APPENDIX E Addtional Non-RAI Requests

(SEIS Figures)

PURPOSE:

This Index of Change documents the modifications requested by the NRC per the additional non-RAI information needs. The following methods are a listing of the specific RAI requests and the modifications made to the original application figures in response to those requests.

Reno Creek Project Met Stations

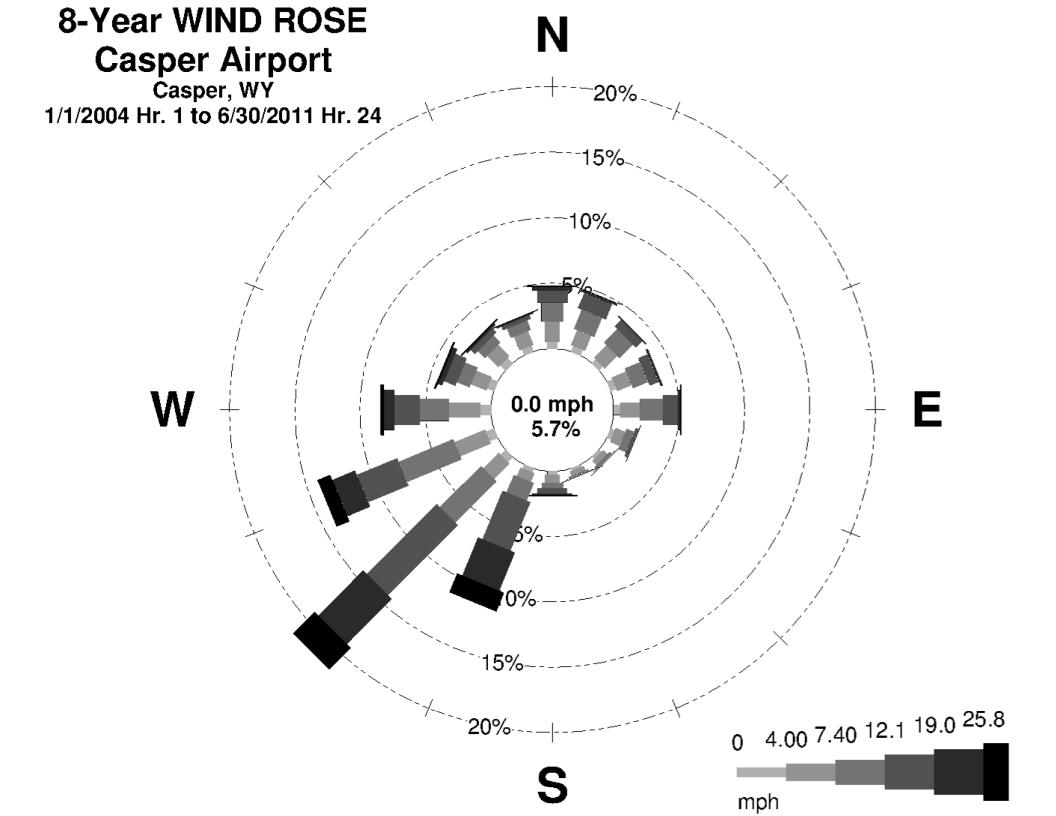
- Change to b/w. Increase size of labels, legend text and symbols, and figure text for readability.
- Enlarge to full portrait page

• No changes, aside from those listed above

25-Year Wind Rose Antelope Mine

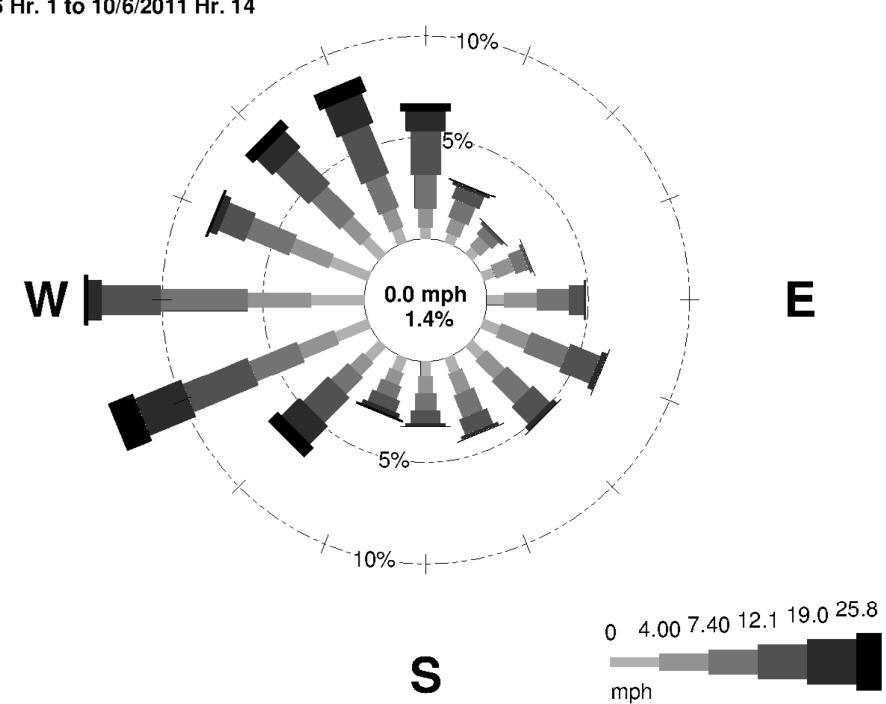
- Change to b/w. Increase size of labels, legend text and symbols, and figure text for readability.
- Add gradient for wind rose

• No changes, aside from those listed above

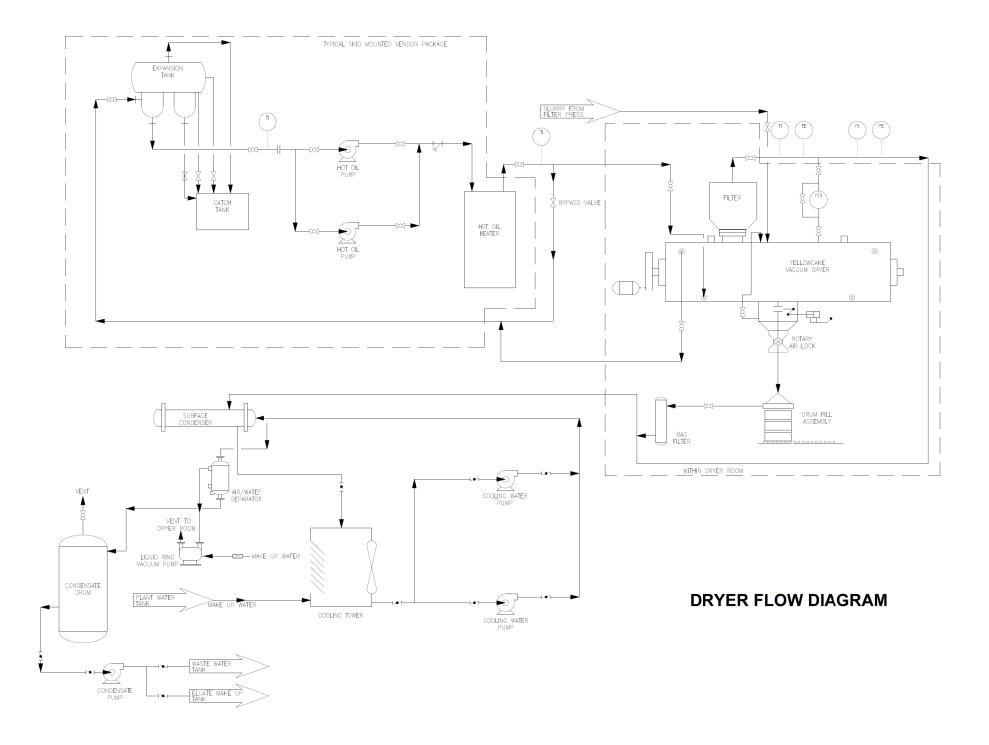
Change to b/w. Increase size of labels, legend text and symbols, and figure text for readability.

• Bar graph was adjusted to accommodate b/w color scheme.

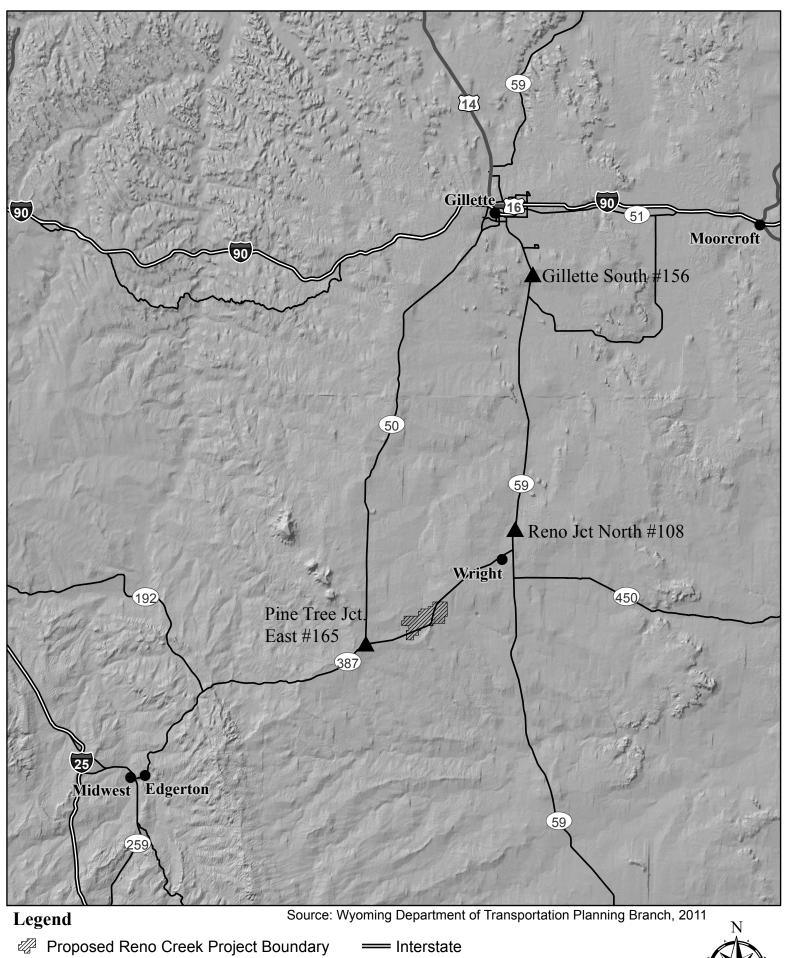
o Change to b/w. Increase size of labels, legend text and symbols, and scale for readability

• No changes, aside from those listed above

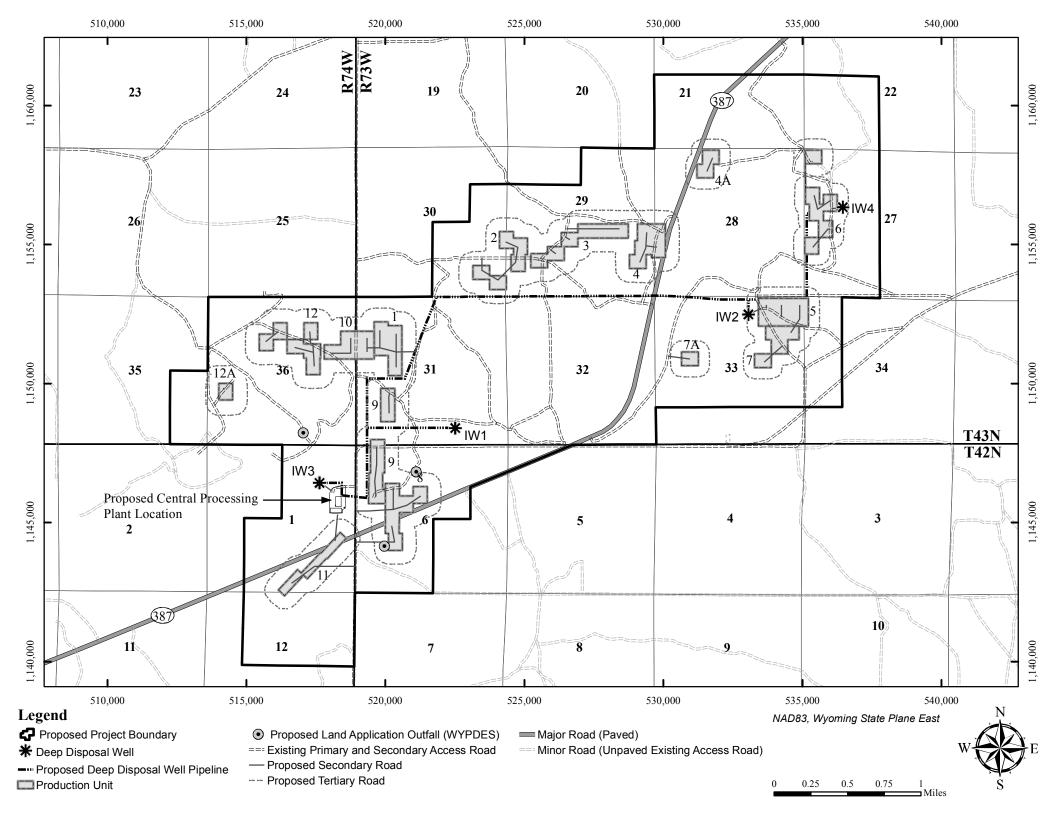
Change to b/w. Increase size of labels, legend text and symbols, and figure text for readability

- Turned off ESRI Shaded Relief Base map service
- Added 30 m hillshade draped on top of a 90 m hillshade (with 5x elevation exaggeration) to add more relief/contrast to the topography.

Land Use Description

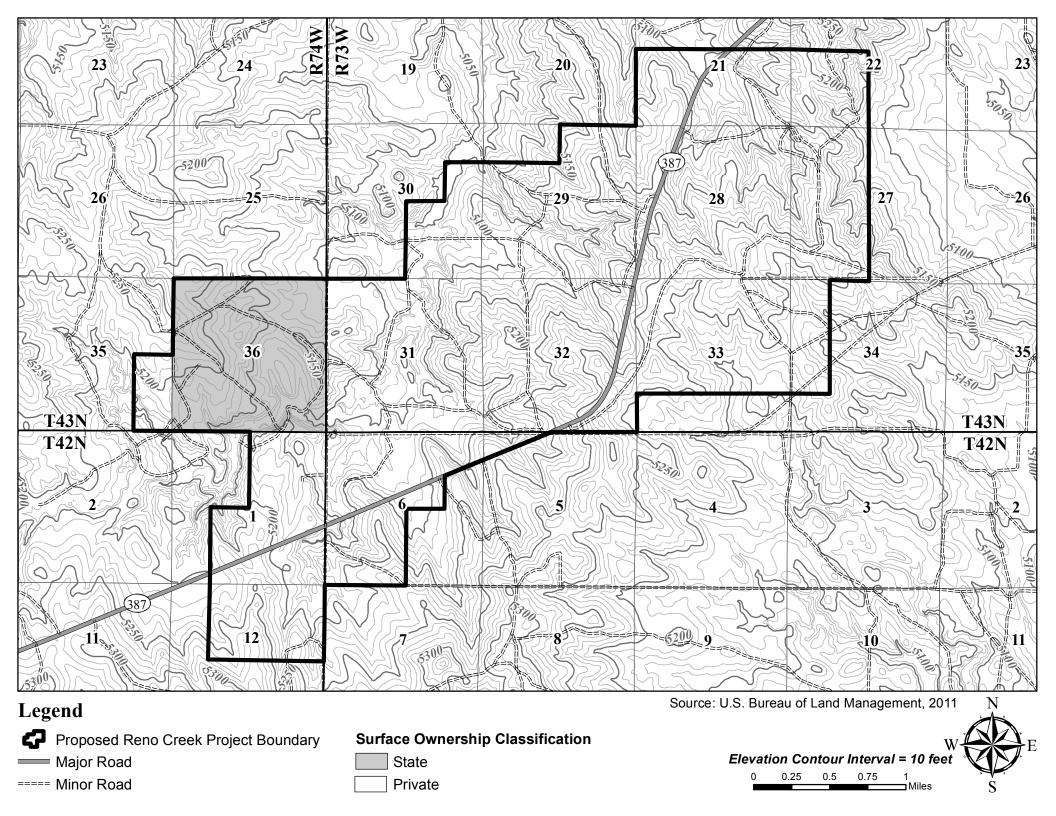
o Change to b/w. Increase size of labels, legend text and symbols, and scale for readability

- Changed symbology of Pipelines to accommodate b/w color scheme
- Changed land use description of "Non-Agricultural" to "Agricultural"

Upper Antelope Creek Watershed

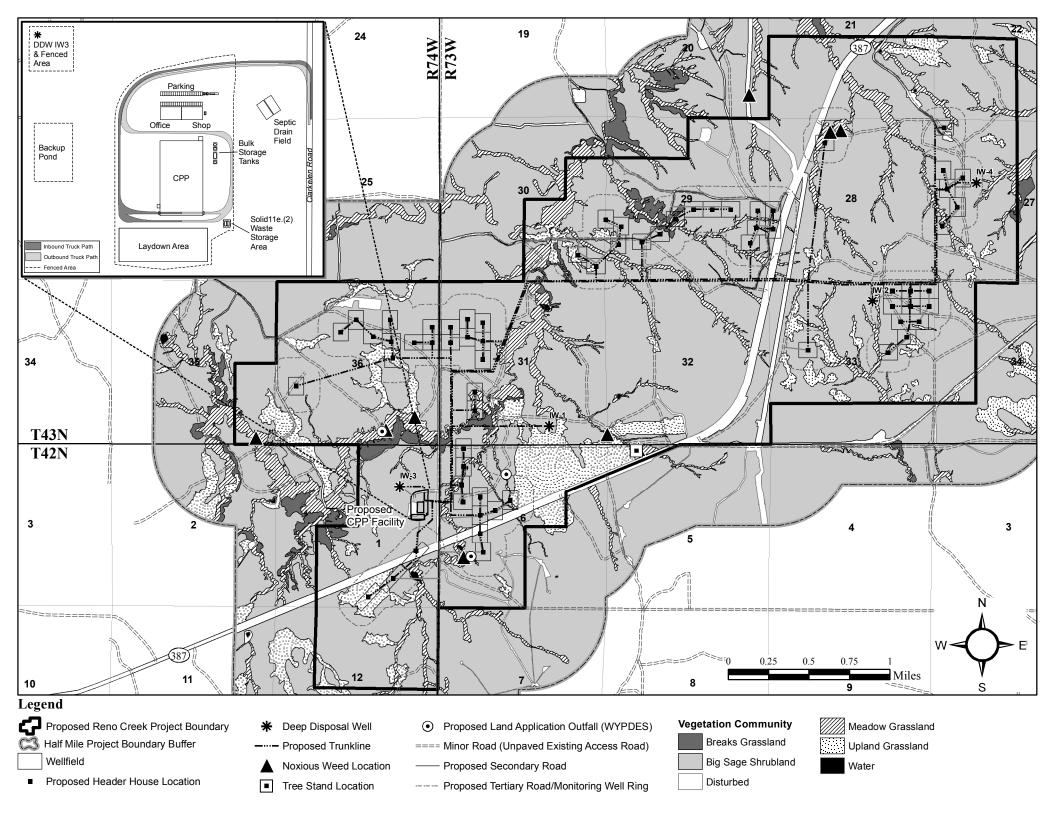
- Reduce size to 8.5" x 11"
- Increase contrasts for contours
- o Increase size of labels, legend text and symbols, and figure text for readability

- Turned off ESRI Topographic Base map service
- Added 30 m hillshade draped on top of a 90 m hillshade (with 5x elevation exaggeration) to add more relief/contrast to topography as requested
- Applied hatch symbology to the Mud Spring Creek and Lower Antelope Creek watersheds
- Additionally, delineated the Upper Antelope Creek watershed

- Applied 2 mile Review Area boundary layer
- Corrected the labels for Upper Porcupine Antelope Creek and Spring Creek Antelope Creek as they were previously incorrectly labeled
- Inserted an inset map to provide a regional reference of the watershed and project area locations.

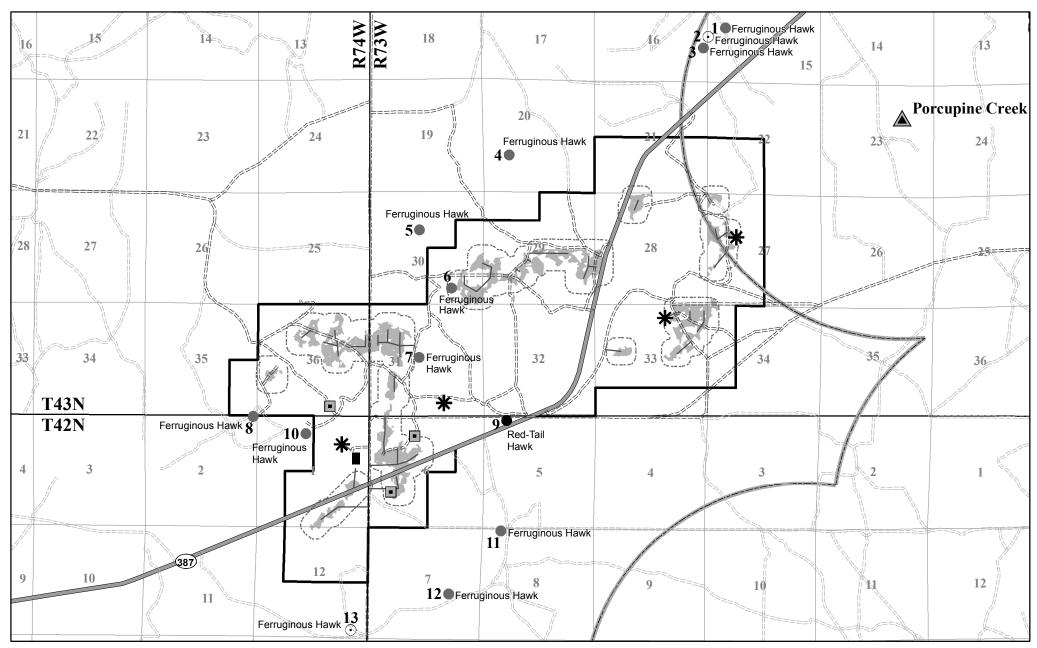
Black/white figure that fits on one 8.5"x11" page, including legend, north arrow and scale showing site boundary. Show the proposed Reno Creek project area and 1-mile wildlife survey buffer (could use ER Figure 3.5-1 as a base). Add WGFD Crucial Habitat Priority Area and an Enhancement Habitat Priority Area for the sagebrush/mixed grassland habitat within Greater sage-grouse complexes (Find these shapefiles. Do not know if they are at http://gf.state.wy.us/web2011/wildlife-1000819.aspx- different from the pronghorn habitat range). Add sage grouse lek locations (160 Acre, Porcupine Creek, and Spring Creek) that are known within 4 miles. Add the 13 raptor nest locations from ER Figure 3.5-1 and identify by species. [there may be updated lek and raptor information provided by WGFD, BLM, etc. that will need to be added to this figure]

- Added Crucial Habitat Priority area (Terrestrial) This was the only Habitat Priority area which intersected the AUC project area.
- Raptor nests and Lek sites remain unchanged

Raptor Nest Sites - 2011 Status

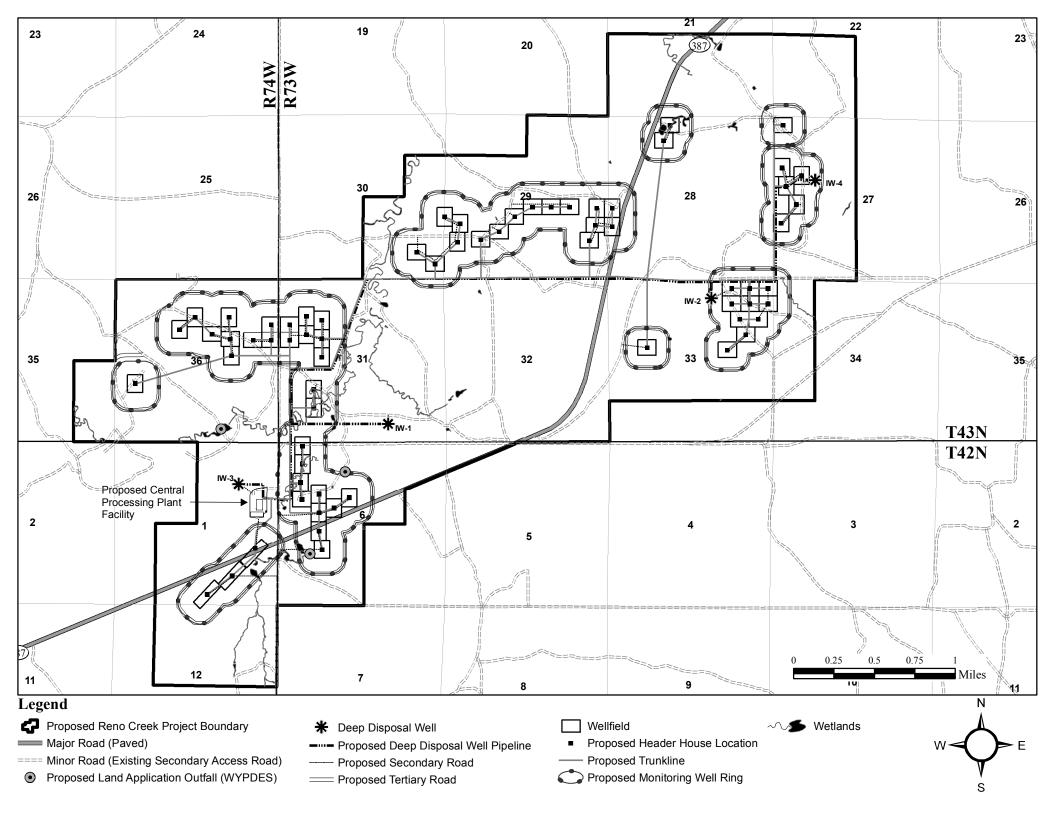
Using this map as a base (reference the file, 'Ecology_Wildlife Features_SEIS.pdf'), create a new figure only keeping the sage grouse lek locations and raptor nests. Place a 2-mile radius ring around the active leks, and add all planned and alternative facilities. The map area can be zoomed in to include just the boundaries of the 2-mile rings. (See Dewey figure 4.6-4 as an example) [there may be updated sage grouse lek and raptor spatial/timing information provided by WGFD, BLM, etc. that will need to be added to this figure]

- Added Deep Disposal Wells, Central Processing Plant, Access roads to the project area, well-field access roads & ore bodies
- Added proposed alternative facilities
- Raptor nests and sage grouse lek sites remain unchanged
- Added two mile sage grouse lek buffers
